**Re: Permit No. M-1980-244; Cripple Creek & Victor Gold Mining Company; Cresson Project; –April 19, 2022 Inspection Corrective Action Response**

**To:** Charles Bissue  
**From:** Jay Janney-Moore, P.E.  
**Reviewed By:** Keith Williams, P.E.  
**Project:** Ore Slope at the Mill Platform  
**Project No:** 475.0106.054  
**Subject:** Review of Ore Slopes at the Mill Platform  
**Date:** May 26, 2022

***Problem/Possible Violation No.2 states "The current mine plan related to ore stacking as approved with TR-103 appears not to have been followed above the HGM".***

CLIENT CRIPPLE CREEK & VICTOR GOLD MINING COMPANY	
PROJECT		VLF2 HEAP ORE SLOPES	
TITLE HEAP ORE COMPOSITE SLOPES ABOVE MILL		FILENAME 0106.054.008F	
		FIGURE NO. 1	REVISION A

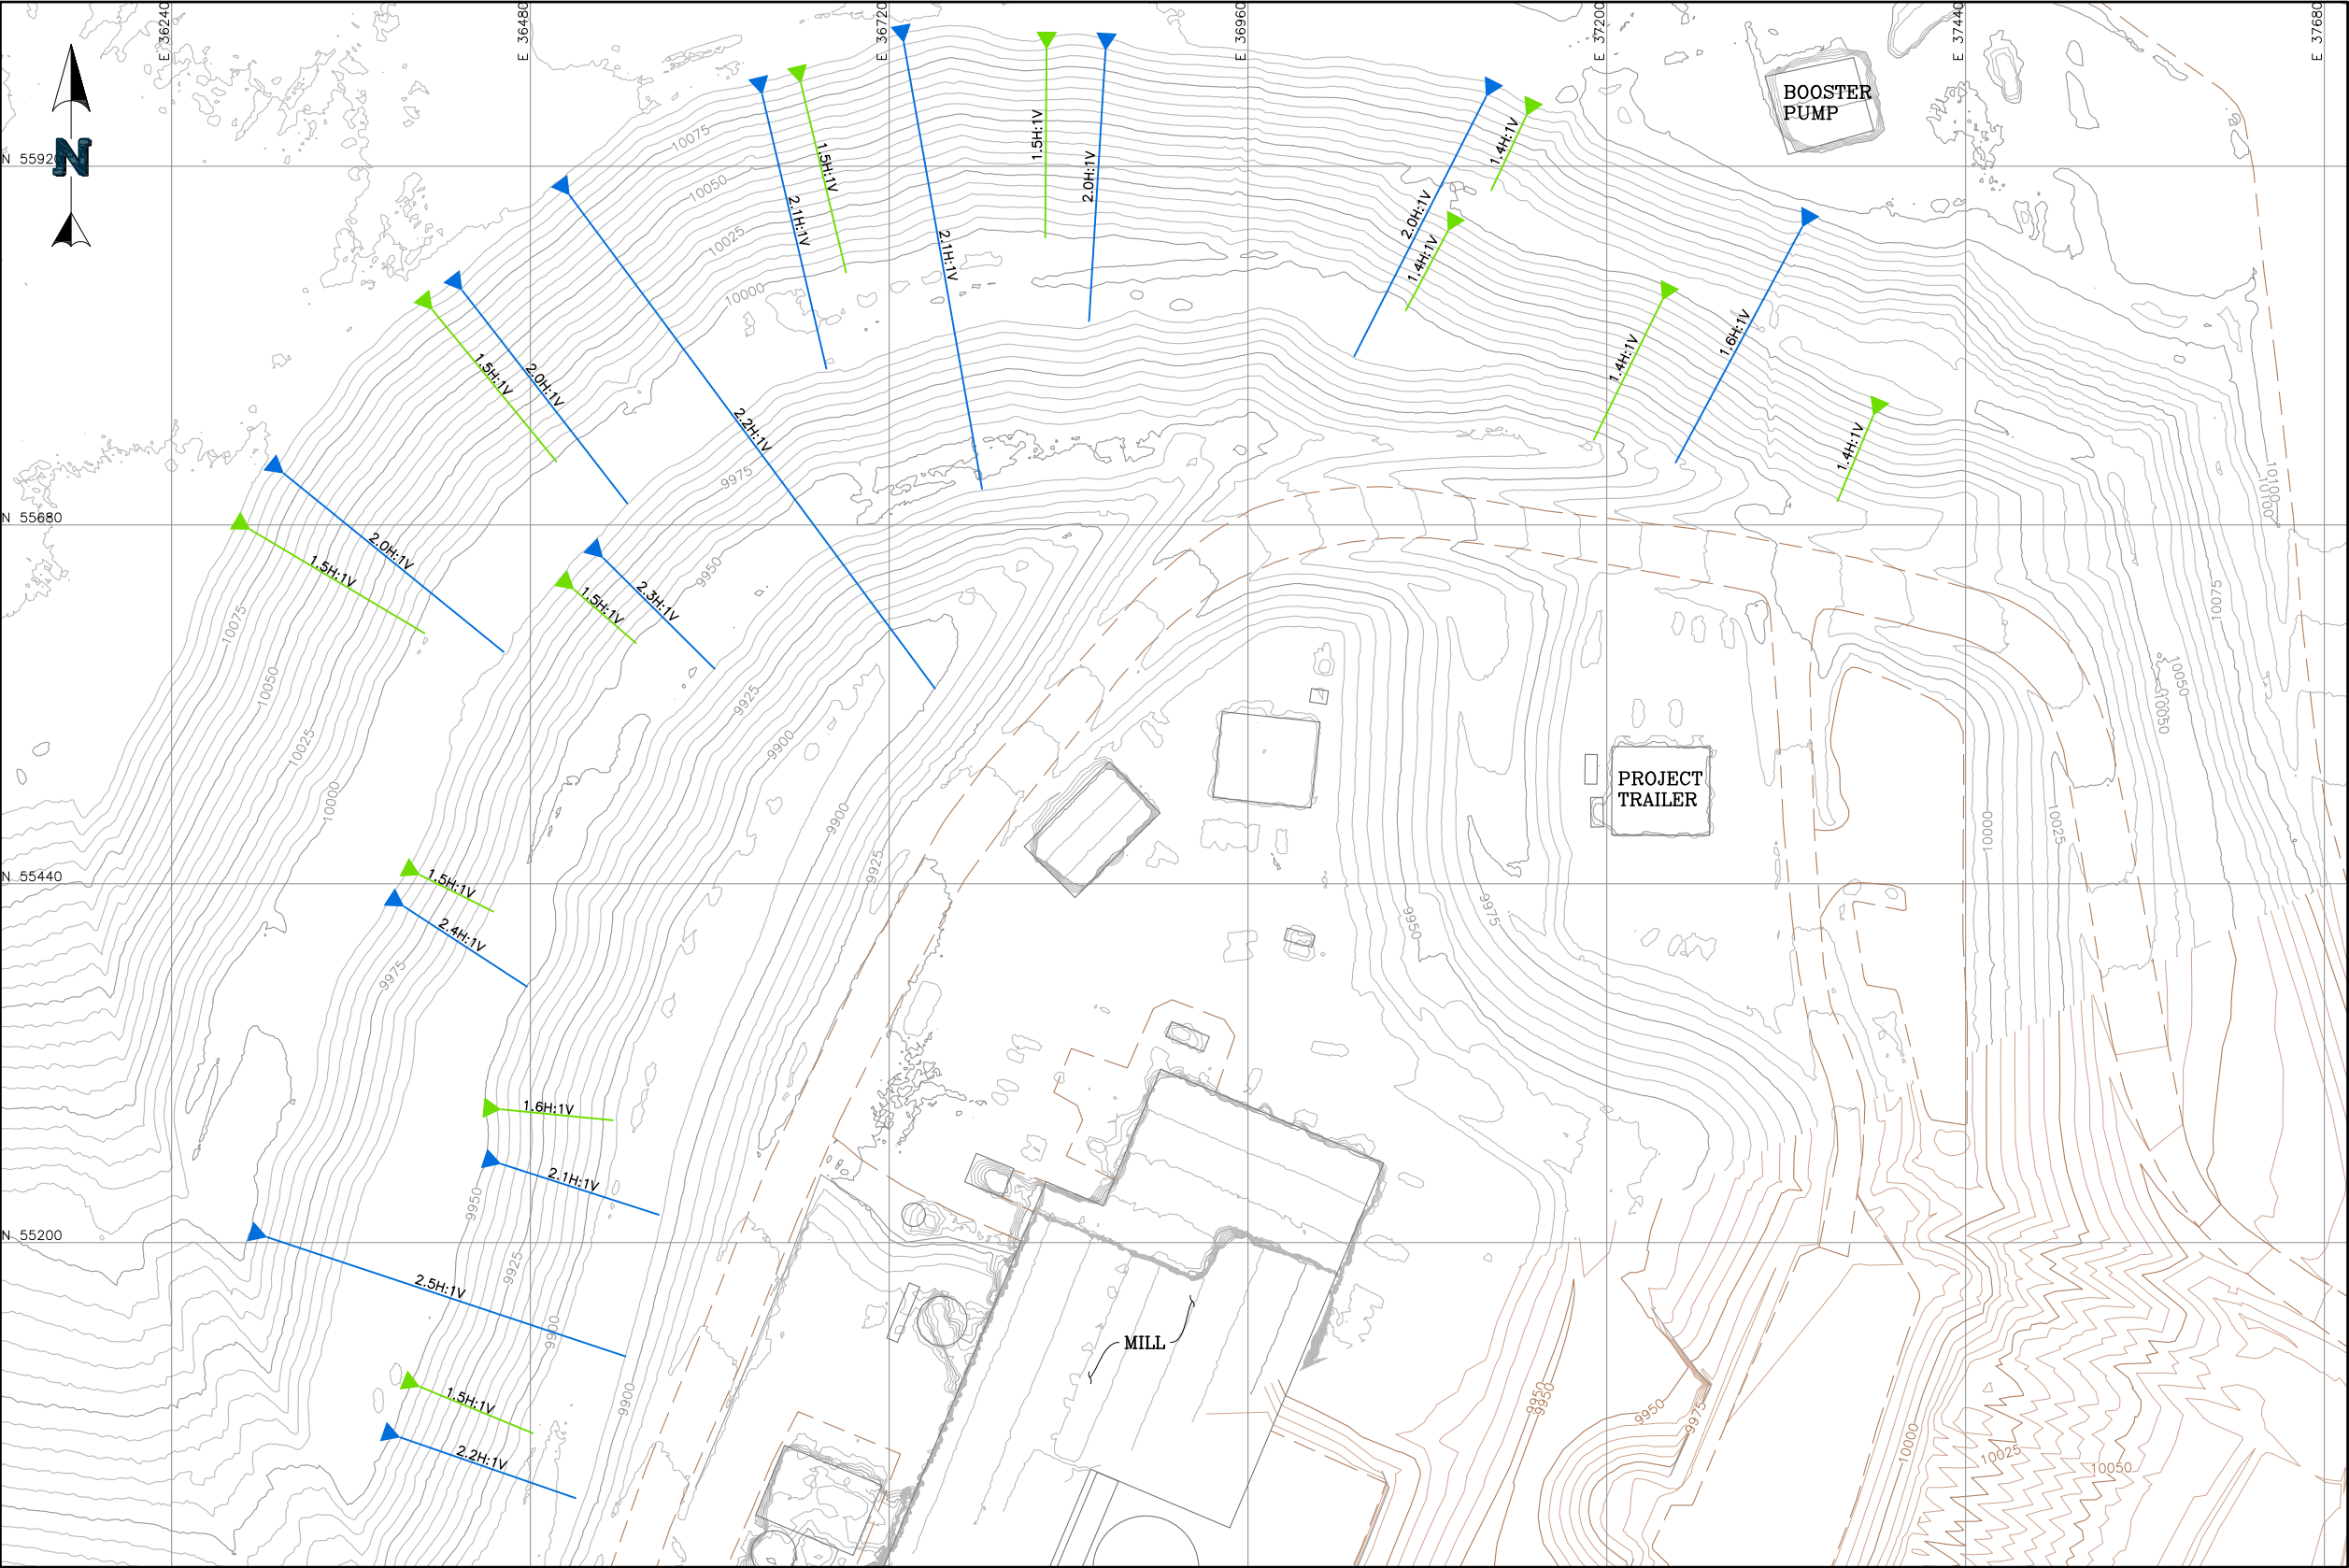
2. *Problem: The current mine plan related to ore stacking as approved with TR-103 appears not to have been followed above the HGM.*

CC&V provided NewFields with a topography file, dated March 2, 2022, of the current as-built ore stacking above the HGM to determine if the stacking was following the guidelines or not. Using AutoCAD Civil3D, NewFields checked the overall slopes of the stacked ore, and checked actual dumped ore angle of repose. As shown on Figure 1, the overall slope of the ore generally varies between 2(H):1(V) and 2.5(H):1(V), except below the Booster Pump building. Based on the southern protrusion in the contours of the upper lift, it appears when the area for the Booster Pump building was regraded, the crest of the slope got pushed out and the overall slope was reduced to 1.6(H):1(V). Additionally, the actual dumped ore angle of repose varied between 1.4(H): and 1.5(H).

The bench width does vary and in some areas is less than 60 feet. This happened because the actual dumped slopes being flatter than the assumed angle of repose stated in Table 1 and not all lifts dumped are 100' thick. It appears CC&V did offset the crest of the subsequent lift to insure an overall slope of 2(H):1(V).

**See the attached drawings and Newfield's Tech memo regarding CC&V's ore stacking above the Mill Platform. Also, please see the attached drawings of VLF2 that display overall operational ore slope, angle of repose, and crest and toe elevations. Lastly, see the geotechnical monthly and weekly scans of VLF 2 indicating no major displacement.**

Based upon the reviewing the actual slopes of the ore above the HGM, it is NewFields opinion that CC&V has stacked the ore above the HGM in accordance with the intent of the guidelines outlined in TR-103 and the overall slopes are 2(H):1(V) or flatter. After subsequence lift of ore are placed above the booster pumps building, the overall slope will flatten out to less the 2(H):1(V).

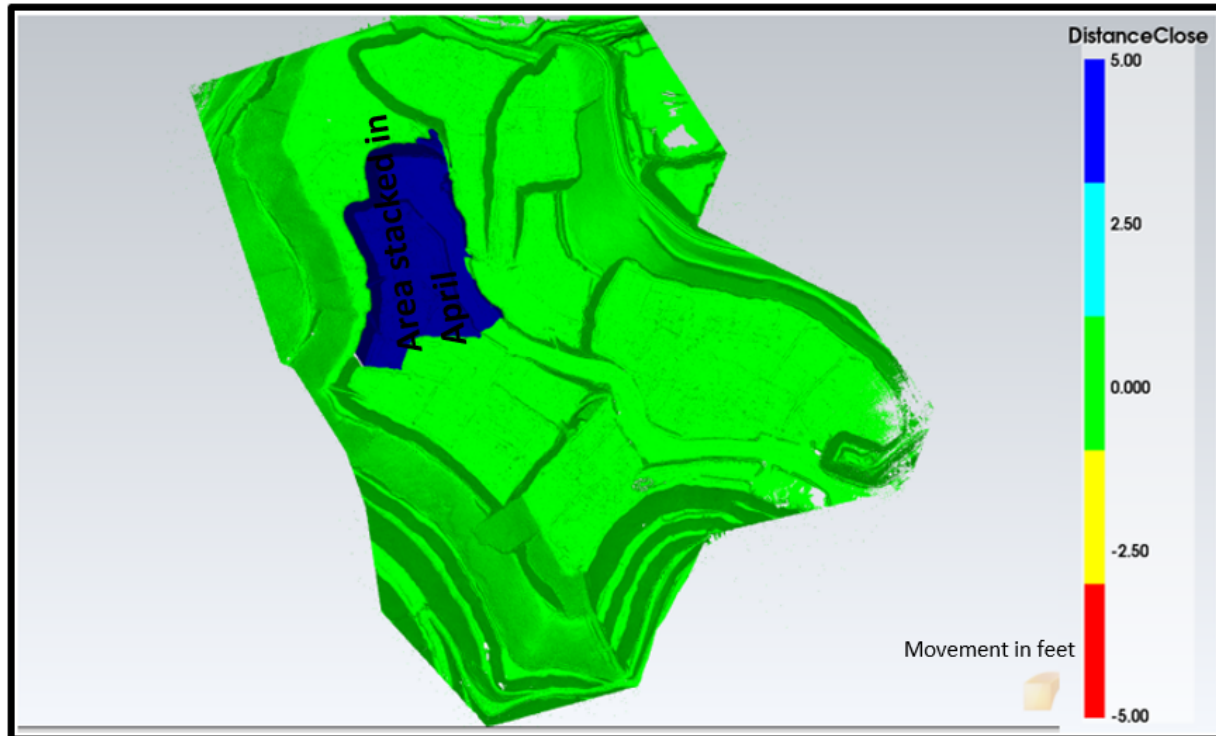
- A march flight of the VLF2 was compared to an April flight to detect displacements in feet
- NO major displacements were detected.

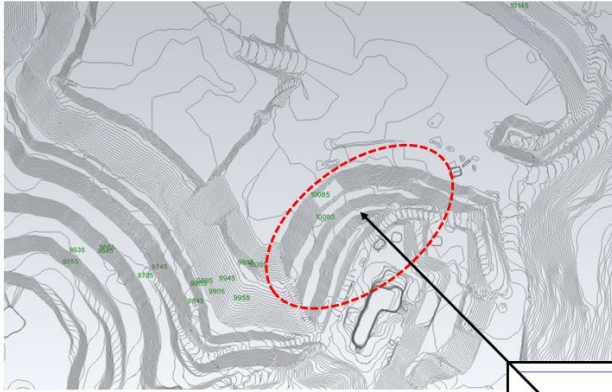
- Weekly scans were compared from April 5<sup>th</sup> to May 9<sup>th</sup>.
- Displacements are calculated in feet
- No major displacements are detected
